SOUTH DAKOTA SCIENCE AND TECHNOLOGY AUTHORITY
RFP 2025-07
4850L Restroom Pipe Network
Amendment #1

SDSTA amends the subject RFP to include the scope of work below:

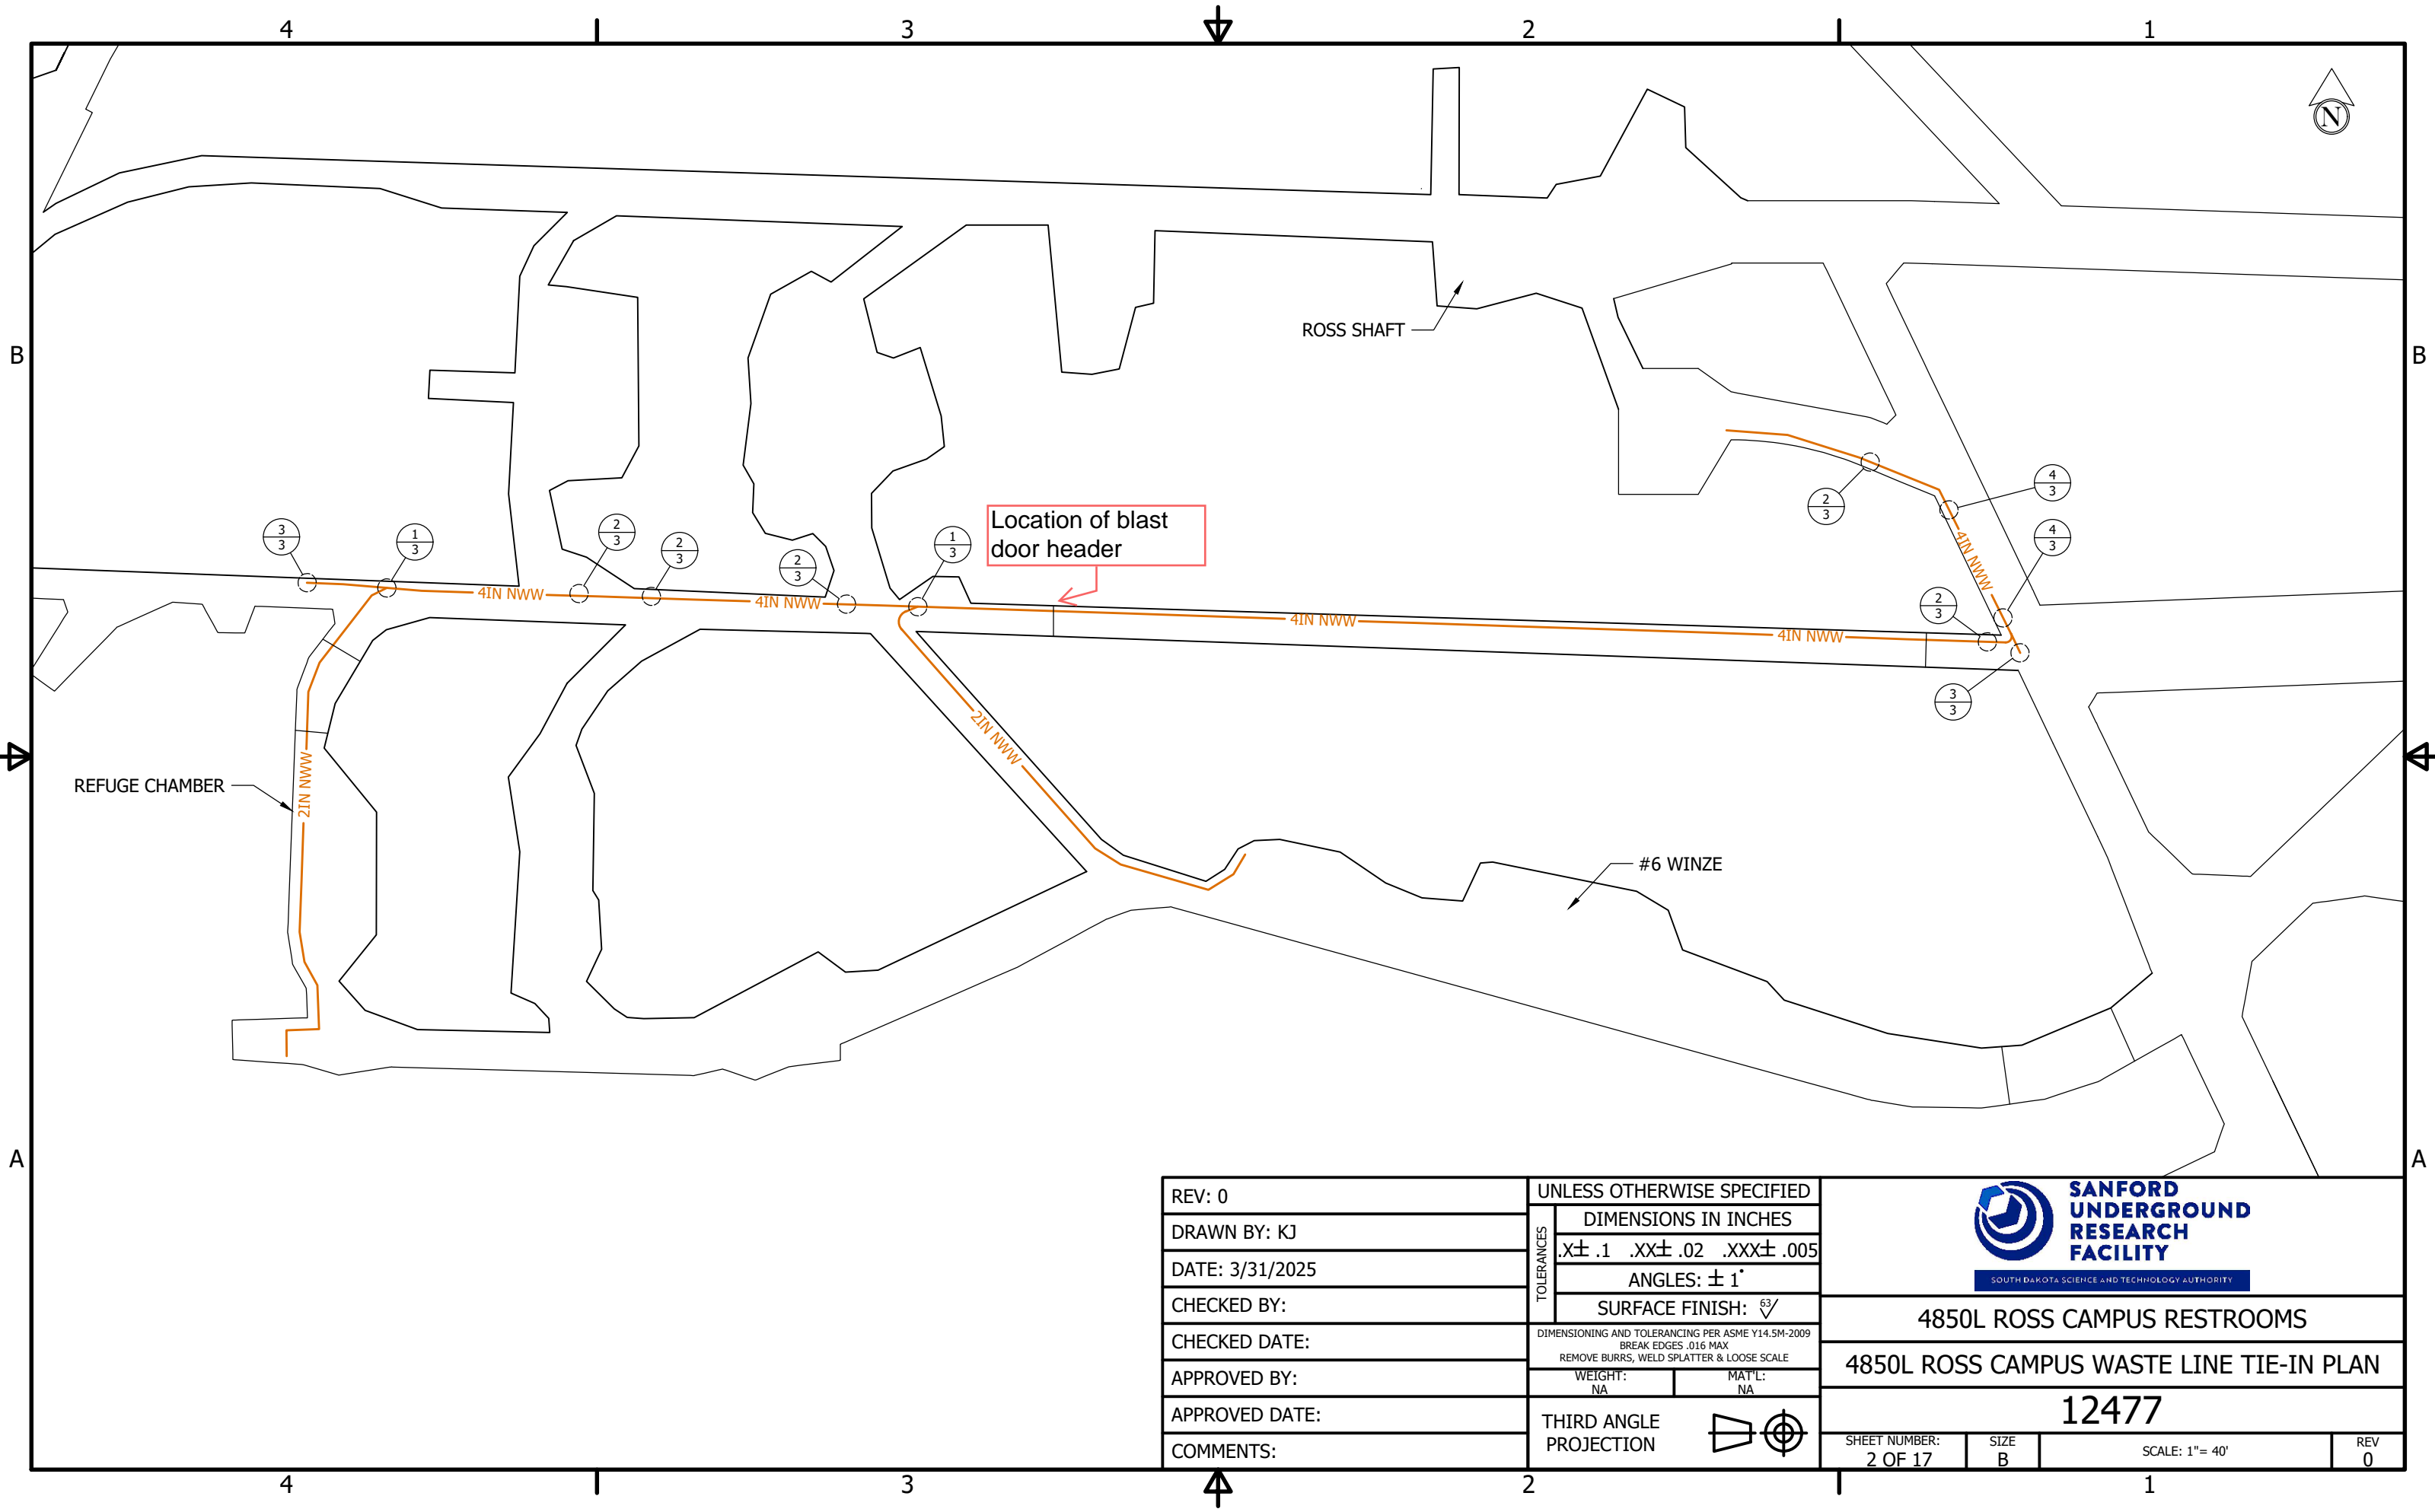
During a post bid project walk-through, SDSTA determined that the remaining blast door frame header is in the direct path of the waste line that will be secured to the existing Unistrut in this area, along with some missing Unistrut sections. SDSTA will replace the Unistrut sections around the blast door frame, but the contractor will be responsible for the following:

- Contractor to core drill through the blast door header (drawing and photos below) with enough clearance to allow the 4" HDPE pipe to pass through.
 - Noted on the drawing - the header is 18" thick concrete, #7 bars @ 12" O.C EW EF with 1-1/2" cover & #4 shear ties @ 12"
 - Contractor to provide all equipment and labor
